Addendum #	02	Date Issued	03/31/2025
Project Name Job #	SWN 0509, Waneta Hall Renovate Restrooms	OSE # R0325--15X	EAPC #20256780
Bid Date Time	April 3, 2025		3:30pm

THIS ADDENDUM AMENDS AND BECOMES PART OF THE CONTRACT DOCUMENTS FOR EAPC PROJECT 20246780 DATED 03/13/2025, RESPECTIVELY. EACH BIDDER SHALL ACKNOWLEDGE RECEIPT OF THIS ADDENDUM BY MARKING THE ADDENDUM NUMBER AND DATE ON THE BID FORM.

DRAWING TITLE
 DEMOLITION PLAN - FIRST FLOOR

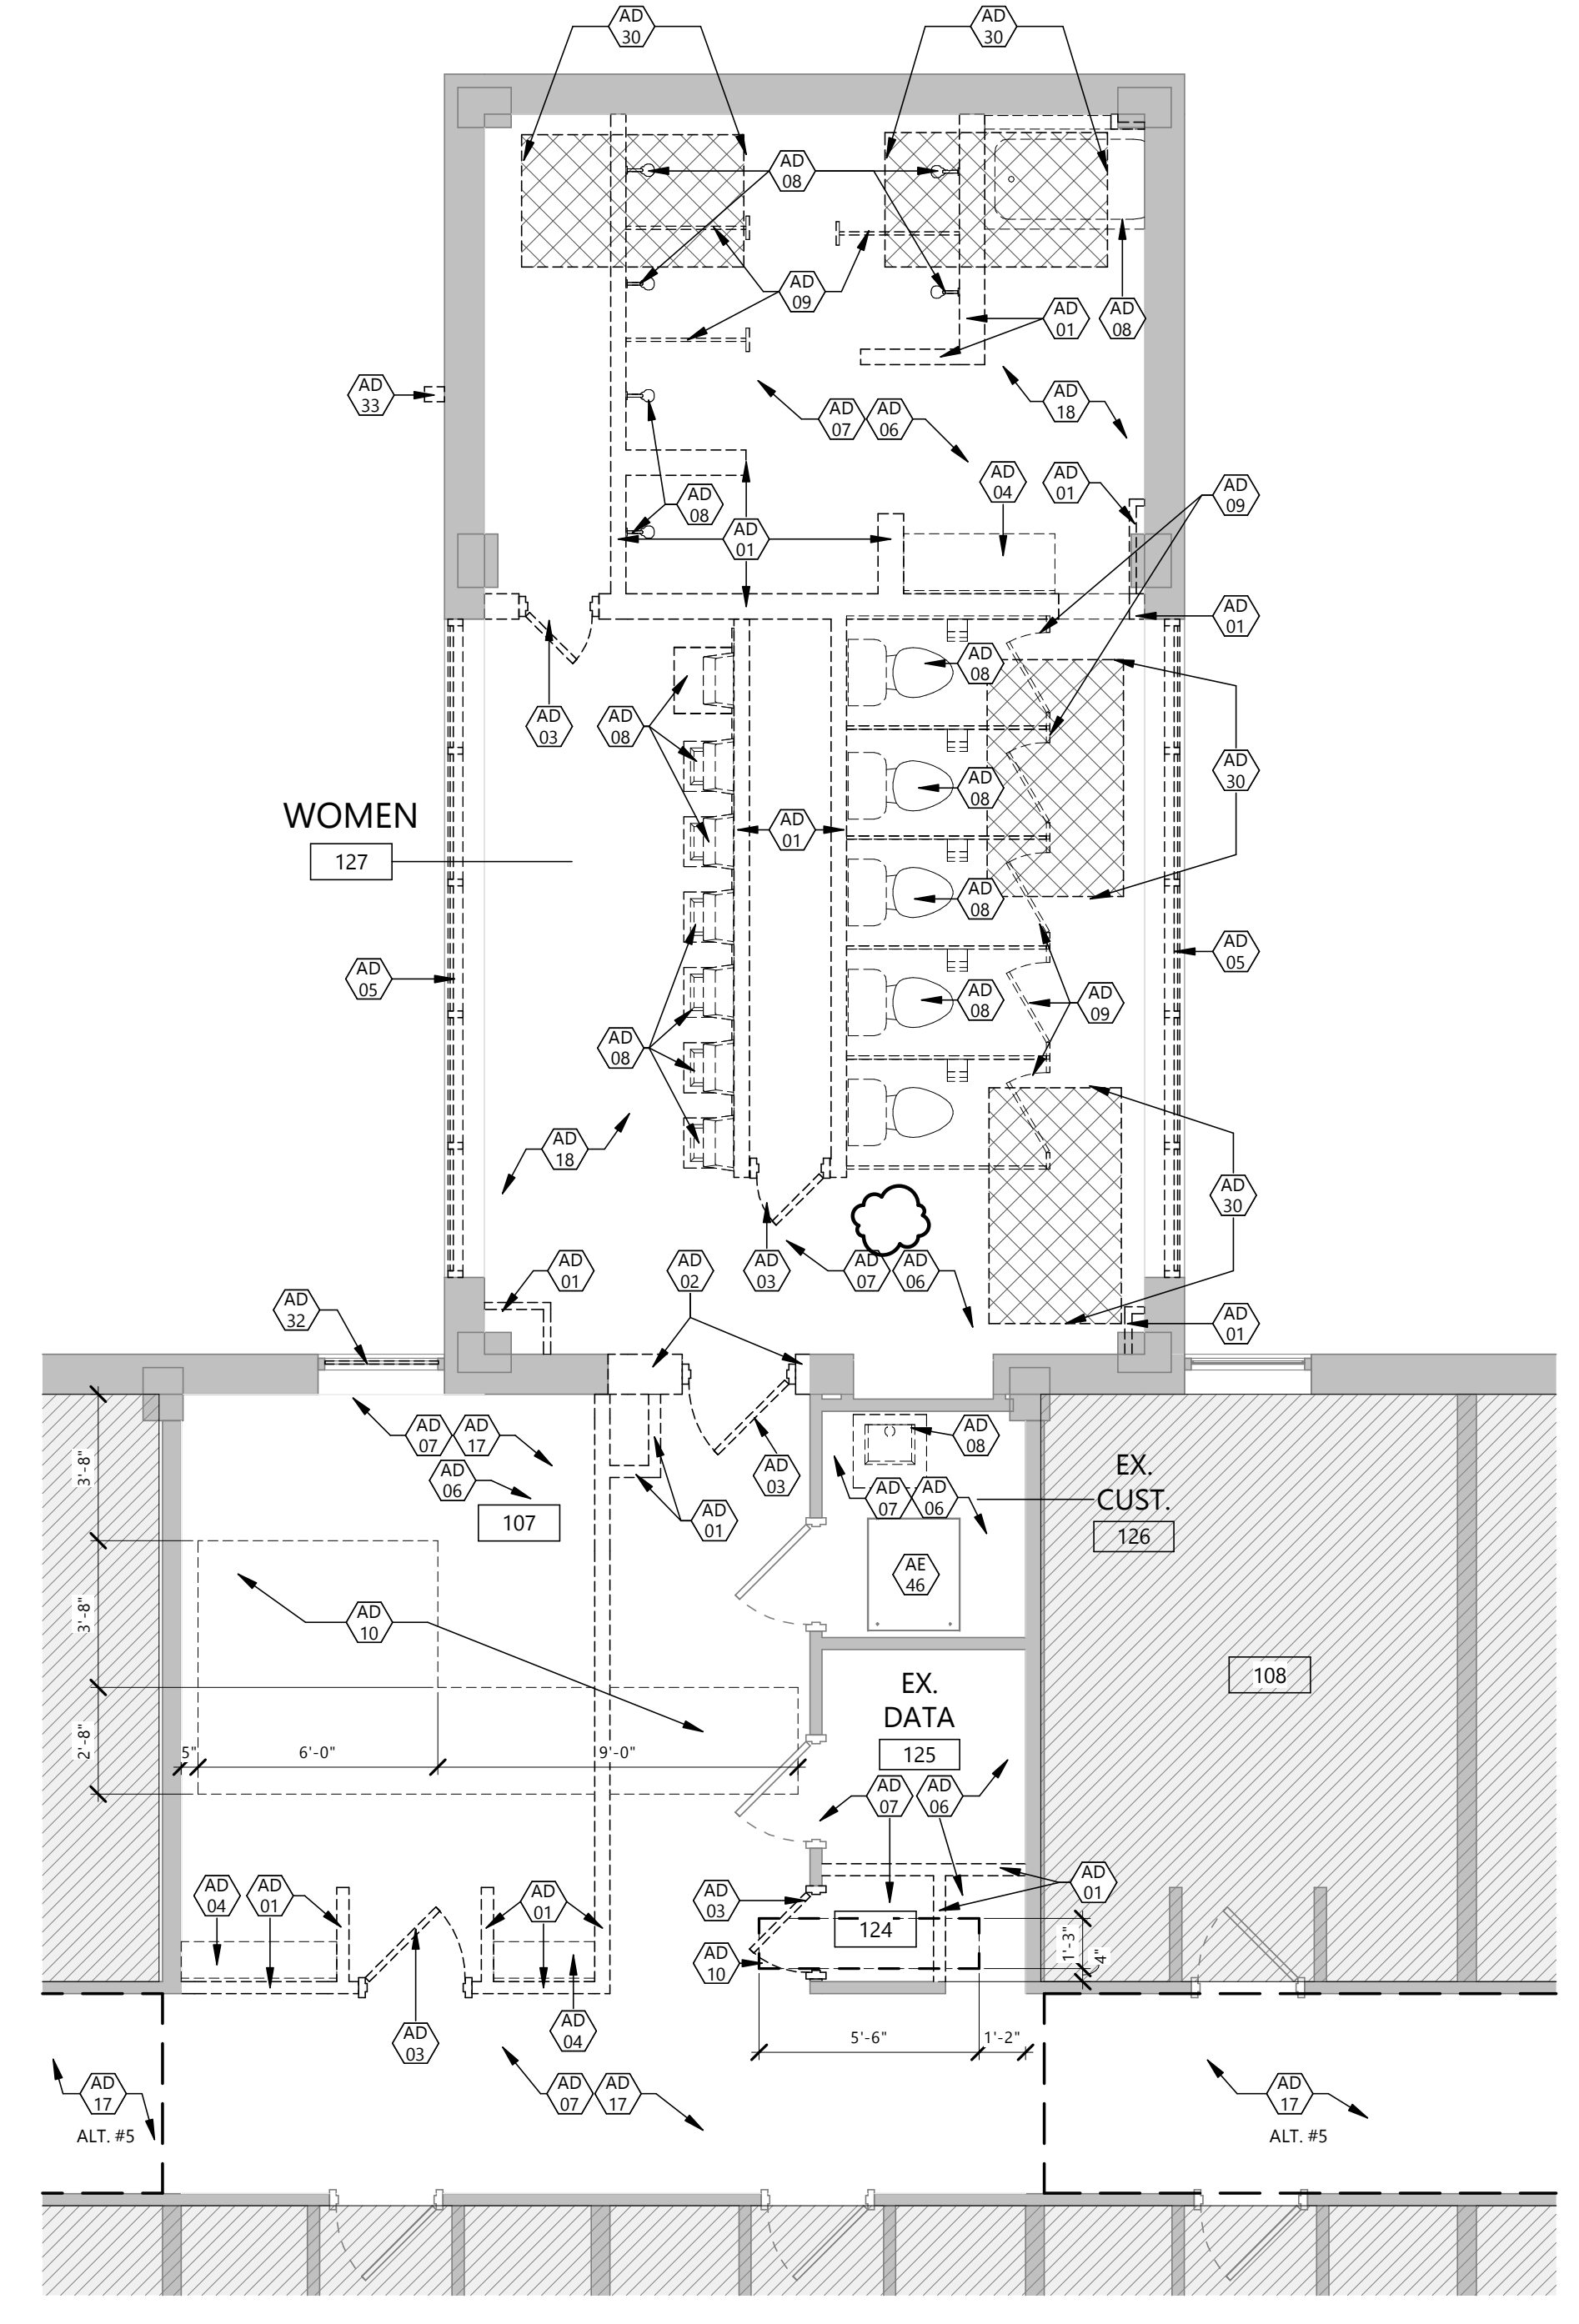
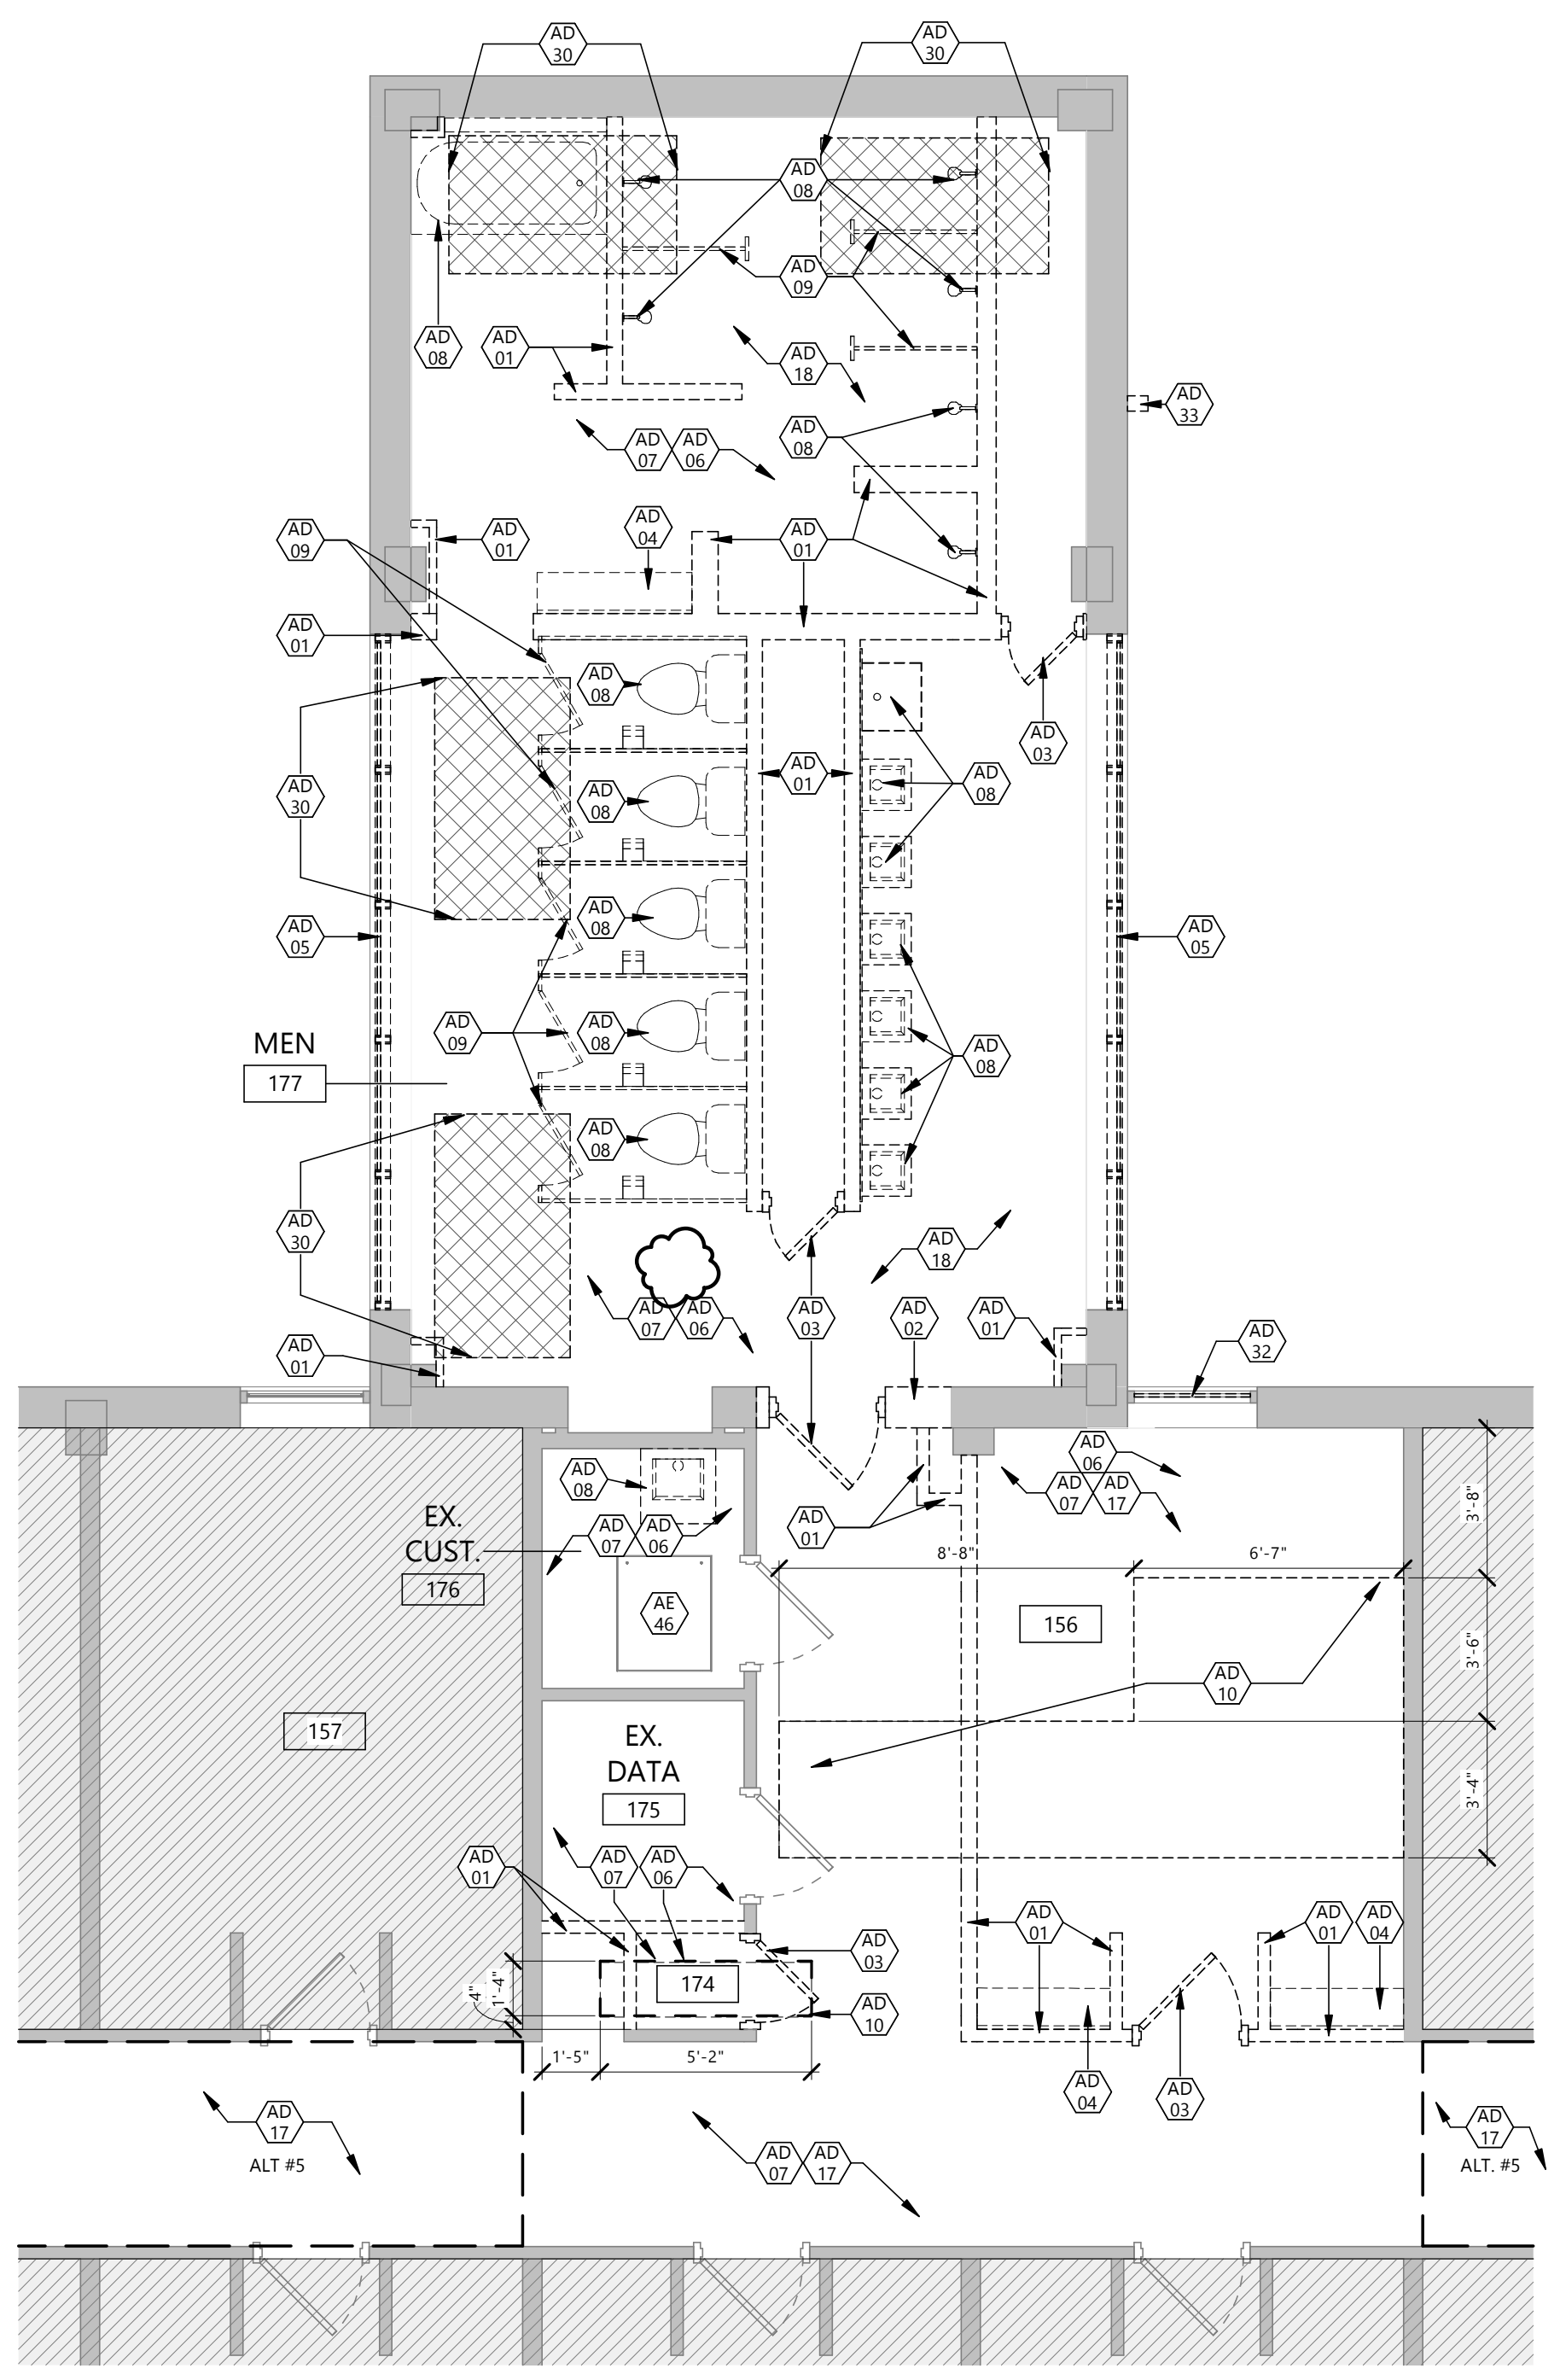
A101	REMOVE Keynote AD 17 at WOMEN 127 and MEN 177 REVISE Keynote AE 33.
A200	ADD Keynote AE 56 and REVISE AE 35 in Keynote Legend.
A221	ADD Keynote AE 57.
A304	REVISE ceiling layout on 1/A304. ADD Keynote AE 55 and REVISE AE 28 in Keynote Legend.
